The following information supplements and/or supersedes the bid documents.

**Hobin Architecture
Incorporated**

JAMB DETAIL 9

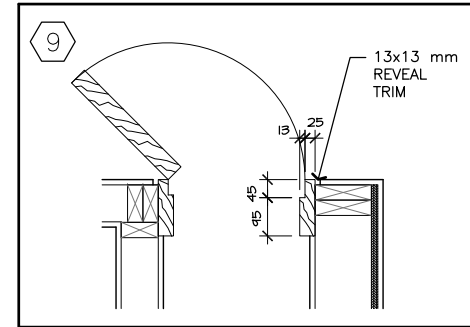
A1.2.4	A2.05	ADD: Horizontal shaft wall ceiling (Wall Type 20) throughout Stair 101, below the sheathing at the underside of the roof trusses. Mount ceiling as high as possible.
A1.2.5	A9.01	ADD: Doors 109.3 and 114.3 to the Door Schedule – refer to attached sketch ADD-A01.1.
A1.2.6	A9.01	ADD: Door Jamb Type 9 – Refer to attached sketch ADD-A01.1.
